D960572-00-V

PROPRIETARY AND CONFIDENTIAL <small>THIS DOCUMENT CONTAINS PROPRIETARY INFORMATION BELONGING TO PROCESS SYSTEMS INTERNATIONAL, INC. OR ITS AFFILIATED COMPANIES AND SHALL BE USED ONLY FOR THE PURPOSE FOR WHICH IT WAS SUPPLIED. IT SHALL NOT BE COPIED, REPRODUCED OR OTHERWISE USED, NOR SHALL SUCH INFORMATION BE FURNISHED IN WHOLE OR IN PART TO OTHERS EXCEPT IN ACCORDANCE WITH THE TERMS OF ANY AGREEMENT UNDER WHICH IT WAS SUPPLIED OR WITH THE PRIOR WRITTEN CONSENT OF PROCESS SYSTEMS INTERNATIONAL, INC. AND SHALL BE RETURNED UPON REQUEST.</small>	V049-3-131	DATA HIGHWAY INTERCONNECTION DIAGRAM			<small>UNLESS OTHERWISE SPECIFIED DIMENSIONS ARE IN INCHES TOLERANCES: FRACTIONAL ± ANGULAR/RADIUS 40°-30° BEND ±2° TWO PLACE DECIMAL ± .01 THREE PLACE DECIMAL ± .005 FINISHED SURFACE RMS BREAK CORNERS IN OUT REMOVE ALL BURRS</small>						PROCESS SYSTEMS INTERNATIONAL, INC. <small>20 WALKUP DR. WESTBOROUGH, MASSACHUSETTS 01581 USA</small> DATA HIGHWAY PLAN LIGO VACUUM EQUIPMENT WASHINGTON SITE RIGHT BEAM MANIFOLD	<small>CAD FILE V0493129</small>	<small>SIZE D</small>	<small>DWG. NO. V049-3-129</small>	<small>REV. 0</small>

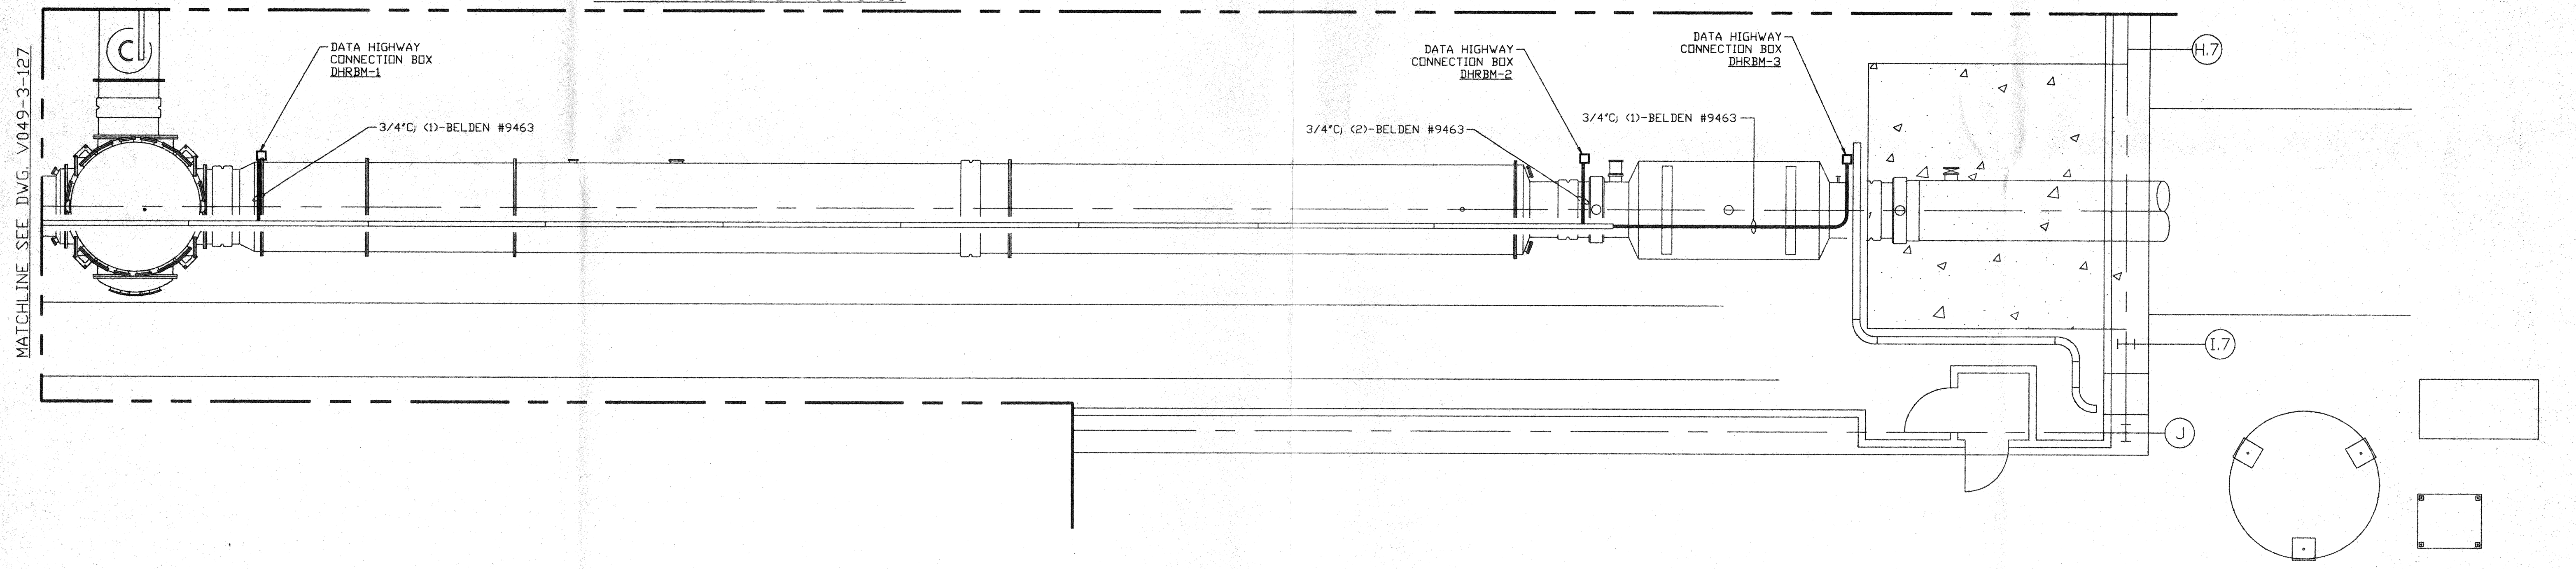
NOTED
CORRECTION
